CXpro^{HD} v1.04

Summary

Constant parameters can now be downloaded in certain modules without the need to cycle the controller outputs, and the LiveLog dialog has been made more intuitive to use.

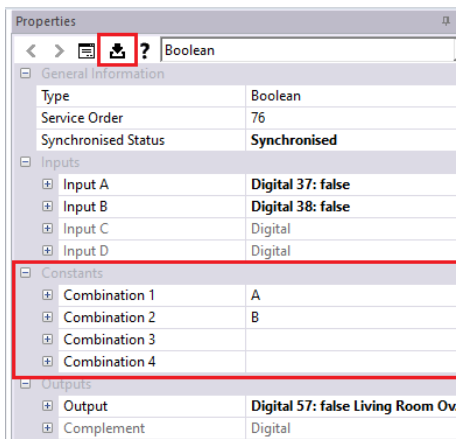
The following image shows the properties for a strategy module that includes this new functionality:

The highlighted button at the top can be selected to download any changes to the highlighted constants parameters, without cycling the controller outputs.

Note: Download of constants will only be possible when all other module parameters are synchronized between the strategy and controller.
